From: Dashiell Leeds [REDACTED]
Sent: Friday, August 4, 2023 12:04 PM
To: Laura Richstone <lrighthouse@cityofsanmateo.org>
Cc: Christina Horrisberger <chorrisberger@cityofsanmateo.org>; Planning Commission <PlanningCommission@cityofsanmateo.org>; James Eggers [REDACTED]; Barbara Kelsey [REDACTED]; Gita Dev [REDACTED] Mike Ferreira [REDACTED]; Gladwyn D'Souza [REDACTED]
Subject: SCLP letter Re: Objective Design Standards

Re: Draft Objective Design Standards

SUBJECT: New development projects in and around Downtown

Re: Draft Objective Design Standards for Multi-Family and Mixed-Use Residential Developments

3rd & Claremont

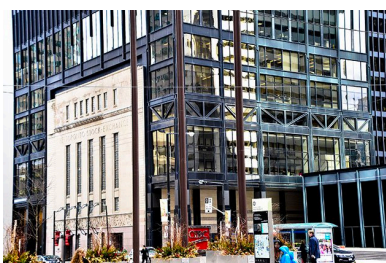
Located just east of the railroad in the Downtown support area, Block 21 and 3rd & Claremont seem to find inspiration in a controversial preservation technique known as facadism. Facadism is sometimes used to construct a new building behind a historic facade. In successful examples, the new building is completely hidden behind the old facade. That is not the case here.

Neither design acknowledges the established pattern of providing changes to the street fronting facade every 25 to 50 feet as advised in the Downtown Design Guidelines. Neither reflects the essential typological or stylistic patterns prevalent in the greater Downtown. The question is where did the developer get the idea these designs would be acceptable or welcomed by the surrounding community.

31-57 S. B Street

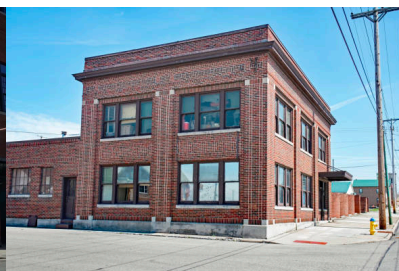
Three projects - 31-57 S. B St. (abutting the Historic District), 405 E. 4th Ave., and 222 E 4th Ave - seem to draw their inspiration from brick warehouses and factories that proliferated during the mid-19th century at the height of the industrial revolution. Popular in the mid to late 1800s, they were generally constructed in the industrial areas of cities, not the Downtown commercial core of urban centers which featured retail shops, mercantile and business offices.

Although sometimes brick cladding may be the appropriate material, and a few of the oldest Downtown buildings are brick, the use of brick does not necessarily equate to compatibility with the Historic District where concrete, stucco, wood and terra cotta were often used. There are some pleasing aspects to all three projects, but because most of the buildings in the Historic District were built after 1900, and the majority of those in the 1920s-30s, the appropriateness of this mid-nineteenth century industrial building type for Downtown is subject to debate. Notably, all three projects have discarded their building corners, something any respectable warehouse would never do.
